# Jamuna Apparels

94/95 (Old), 46 (New), Block –C, Tongi I/A, Tongi, Gazipur  
(23.901086N, 90.399888E)

7<sup>th</sup> November 2013

# Building Observations

## Beams grids G/6-7 & F/3-5

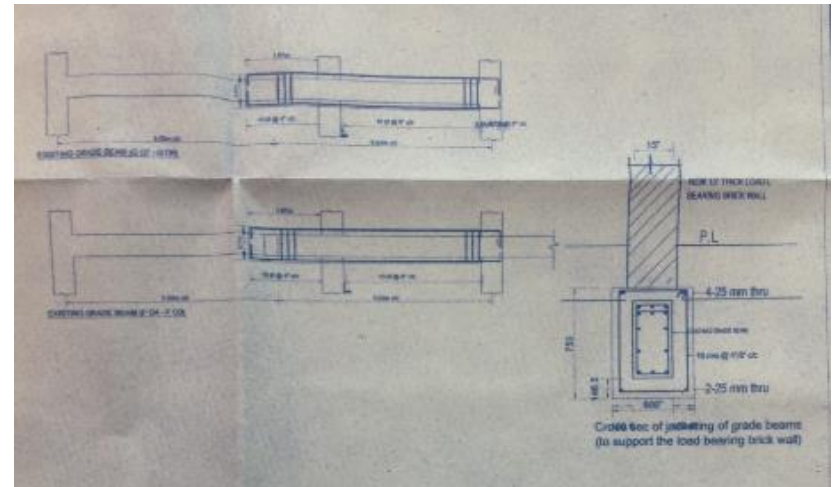
Columns supporting the beams indicated are offset from the main grid. From a cursory check of the reinforcement drawings the beams indicated do not comply with code requirements.

Available safe pile capacity	105 ton/pile	hammer	More than adequate
E.	Required thickness for pile cap as per existing loading	30 inch	Analysis	
	Provided thickness for pile cap	24 inch	Drawings and by re-bar scanning	
			Site investigation	Four pile caps (F4, G5, G6, G7) are inadequate

portion	beams and 0.96 in2/d as stirrup	bar scanning test	
6.	Required reinforcement in maximum loaded beams in south portion as per existing loadings	2.85 in2 top rebar in 27.5" depth beams and 0.72 in2/d as stirrup	Analysis (1.05D + 1.275L + 1.4025E)	Two beams (G3 to G7 and F3 to F5) are inadequate
	Provided reinforcement in maximum loaded beams in south portion	3.5 in2 top rebar in 27.5" depth beams and 0.72 in2/d as stirrup	Drawings and by re-bar scanning test	
7.	Required reinforcement in maximum loaded beams in north portion	2.27 in2 top rebar and 0.48 in2/d as stirrup in 27.5" depth beams	Analysis	Adequate

**Remedial Solution for beam support to be implemented as per Checking Engineers report**
